FRASERS PROPERTY

EASTERN CREEK BUSINESS HUB
AMENDED STAGE 2 DA –
PROPOSED SPECIALISED RETAIL
CENTRE FOR LOT 1 –
TRANSPORT ASSESSMENT

SEPTEMBER 2019
(AMENDED DECEMBER 2019)

6.4m SMALL RIGID VEHICLE
SWEPT PATHS

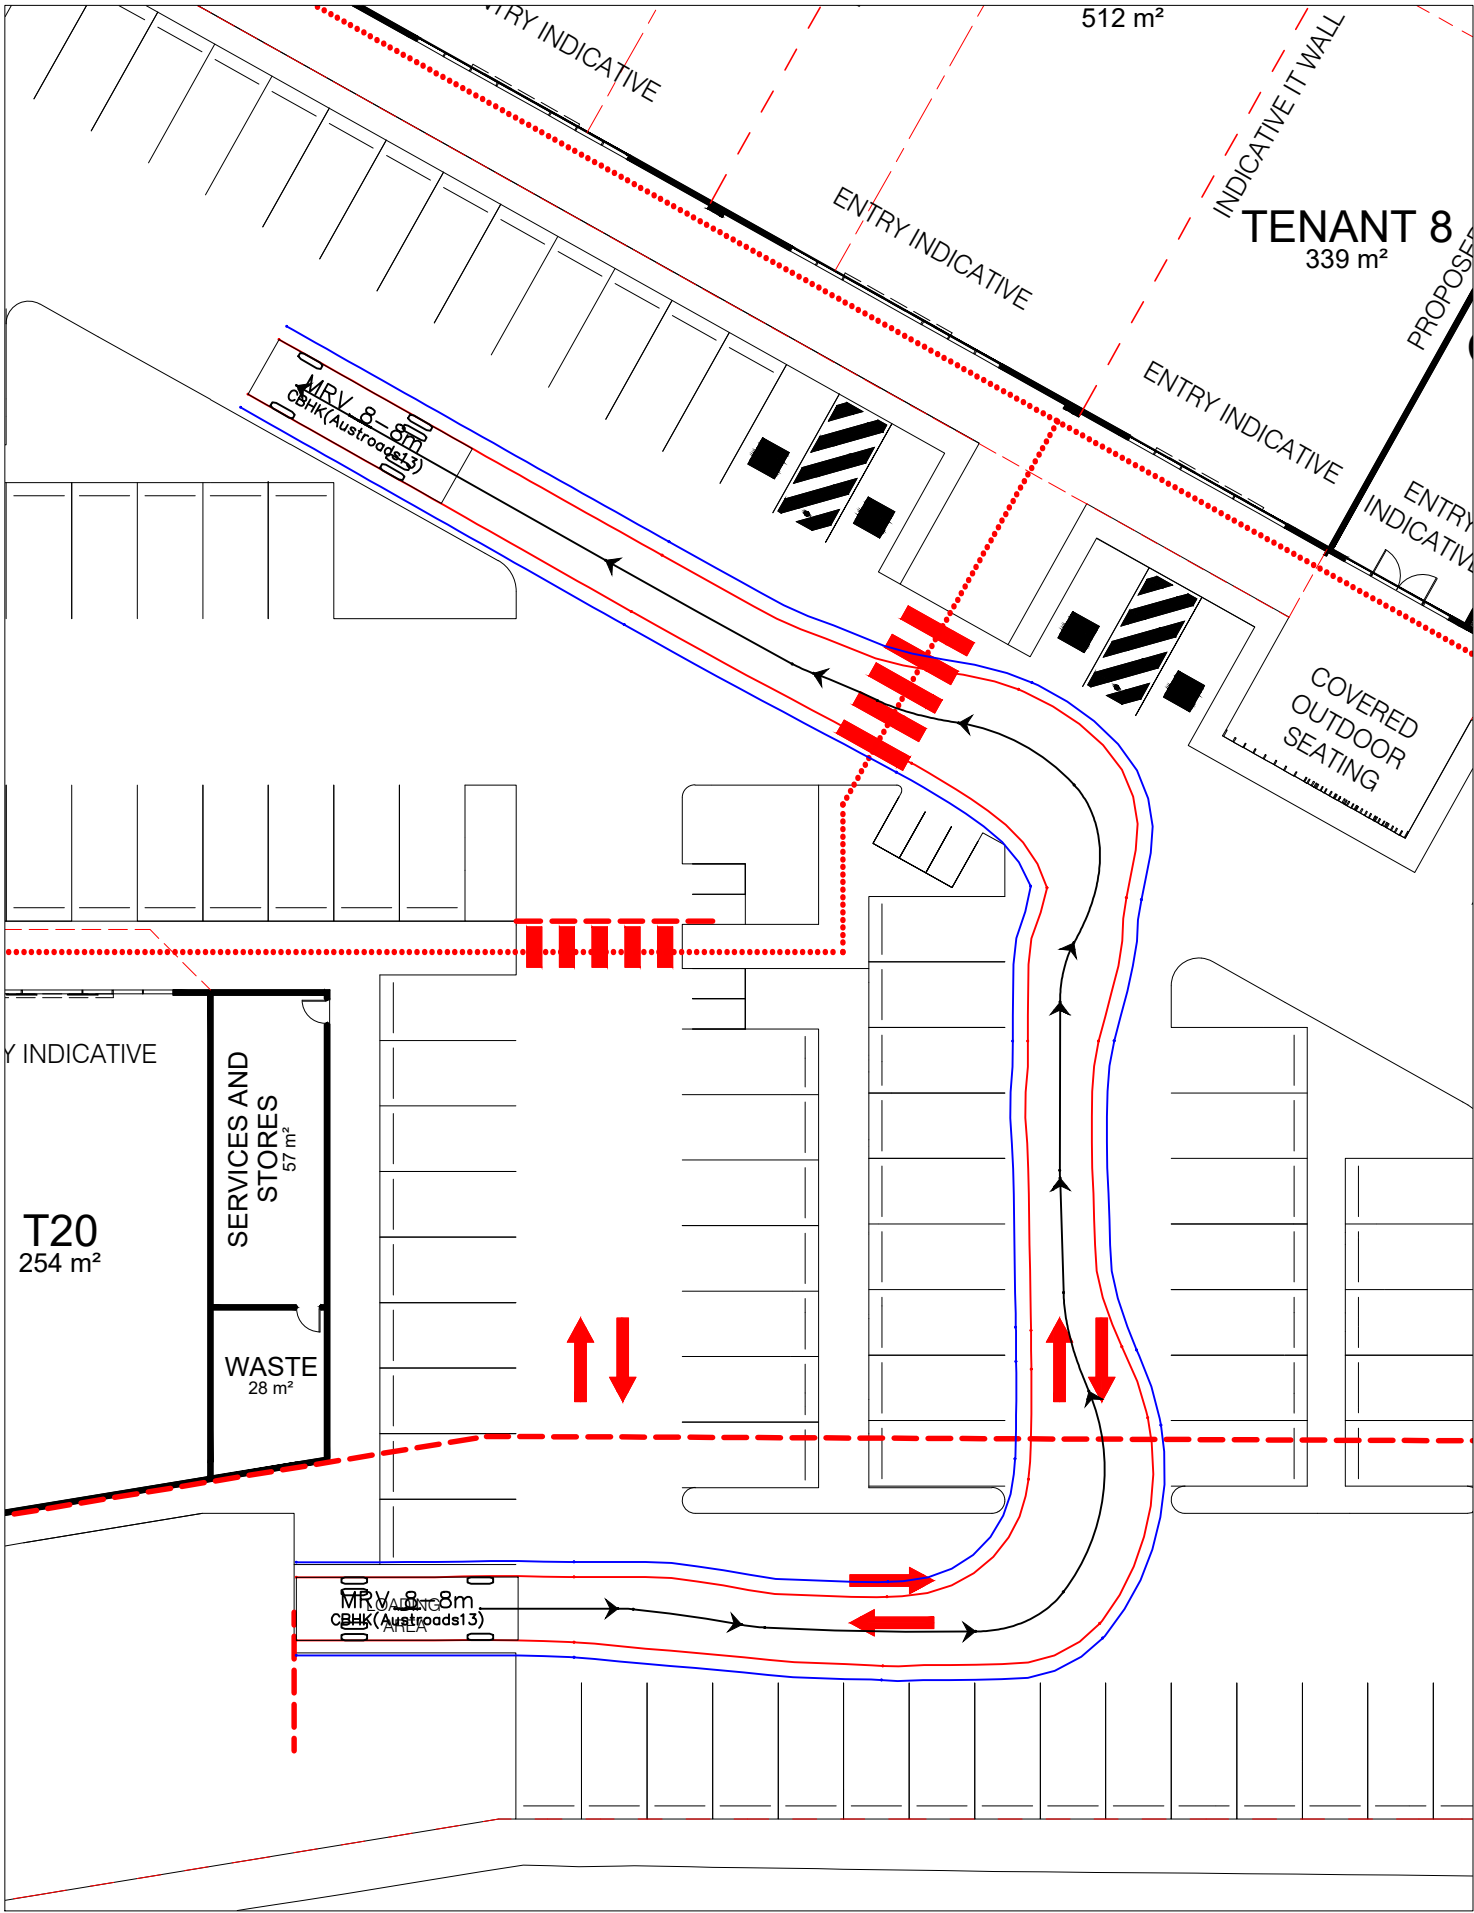
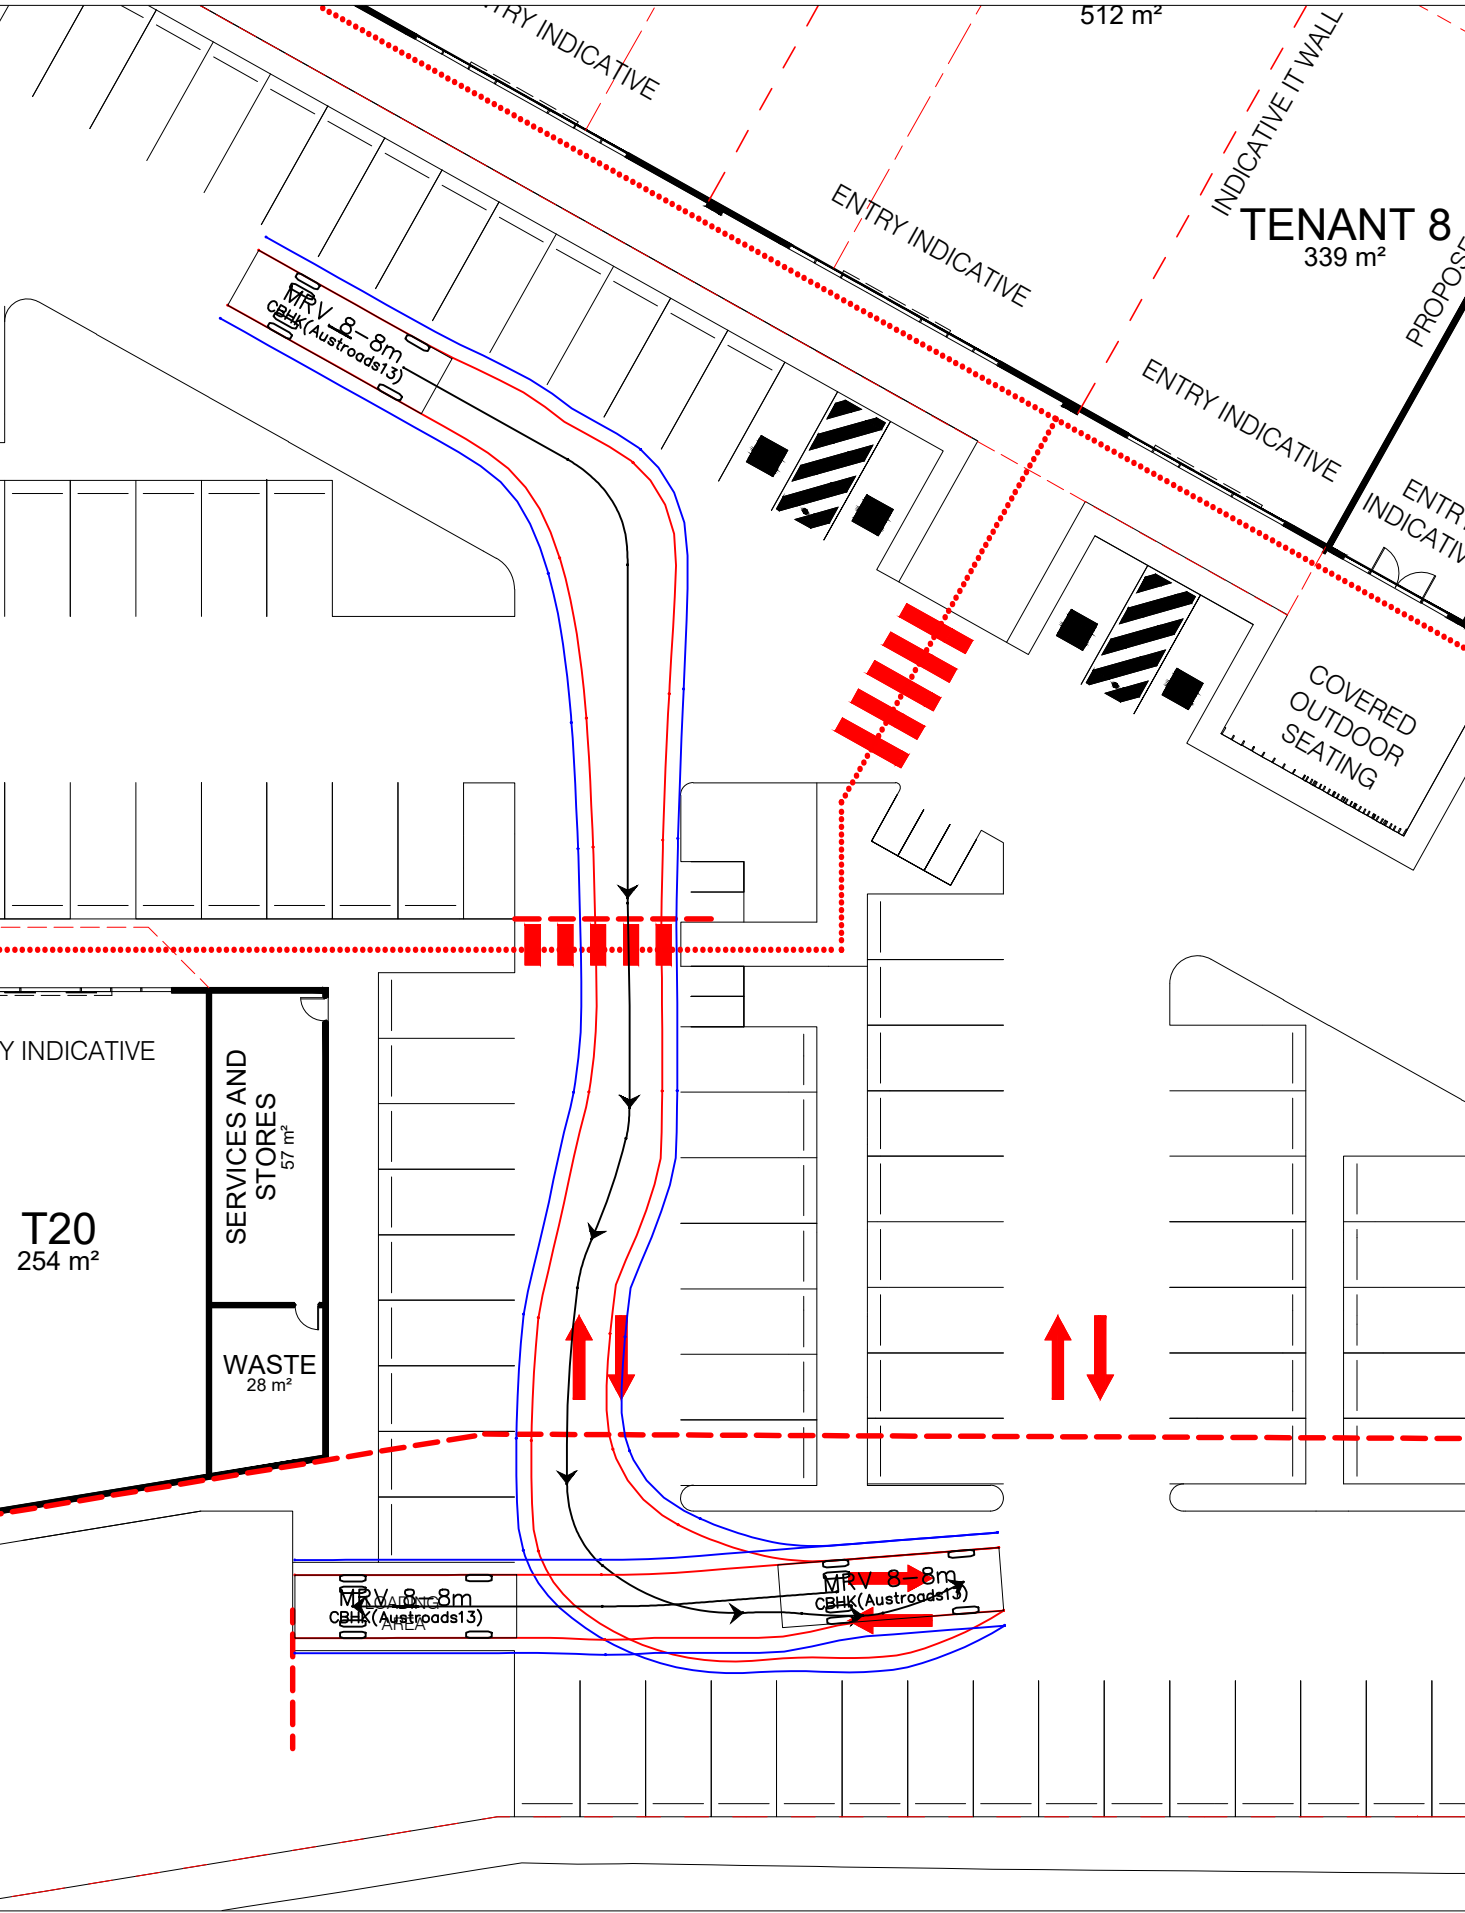
Clarify the loading and unloading arrangements for buildings 2 and 3

- 2.47 Building 2 will be serviced by vehicles up to 6.4 metre long small rigid trucks. Building 3 and the PAD site will be serviced by vehicles up to 8.8 metre long medium rigid trucks. A loading dock will be provided for each building with access via the at-grade car park. Deliveries will occur outside of busy trading hours. Service vehicle swept paths are attached.

20.0m ARITUCLATED VEHICLE SWEEP PATHS

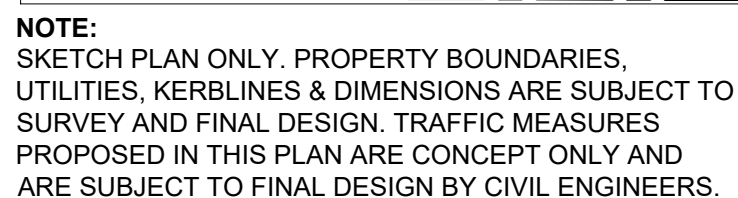
iii. The turning diagrams show that a 19 metre long articulated truck would have difficulty to turn at the roundabout as well as along the tight bends on the proposed truck

2.42 The attached truck turn paths show that a 20 metre long articulated truck can access Lot 1 and travel through the roundabout satisfactorily.
